SERVICE BULLETIN

APPLICABILITY: 2000~2003MY Legacy Wagon/Outback **NUMBER:** 15-104-01
SUBJECT: Roof Rack / Crossbar Wind Noise **DATE:** 11/01/01

Figure 1

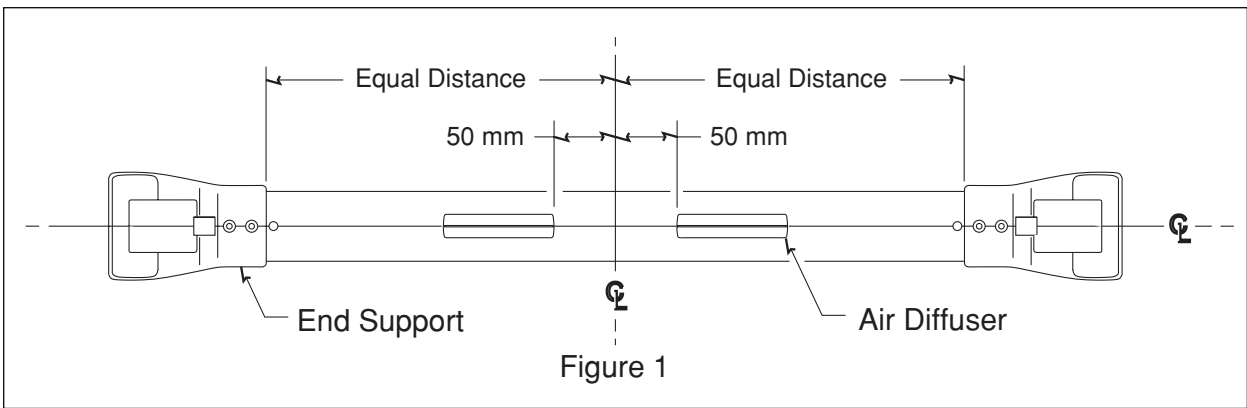
- 3) NOTE: Each Crossbar has a different centerline. Locate the Crossbar center by measuring the distance between both End Supports and dividing by 2. Mark with a grease pencil. (see Figure 1.)

- 4) Measure along the centerline of the Crossbar 50 mm on either side of the mark and again make a mark. (see Figure 1.)
- 5) Remove the Protective Backing from the Air Diffusers just prior to installation and apply to the surface ensuring they are centered and straight. Apply even pressure for 15 seconds.

Figure 2

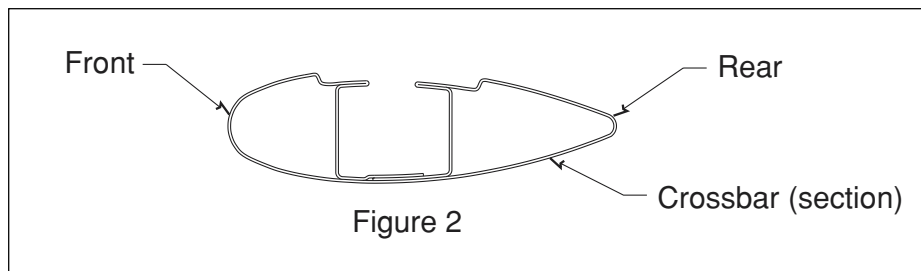
NOTE: Both Crossbars have a label indicating the direction of mount. If they are not present, orient with the larger section of the Crossbar towards the front of vehicle (see Figure 2). The Front Crossbar also has a MAXIMUM LOAD Label affixed to it.
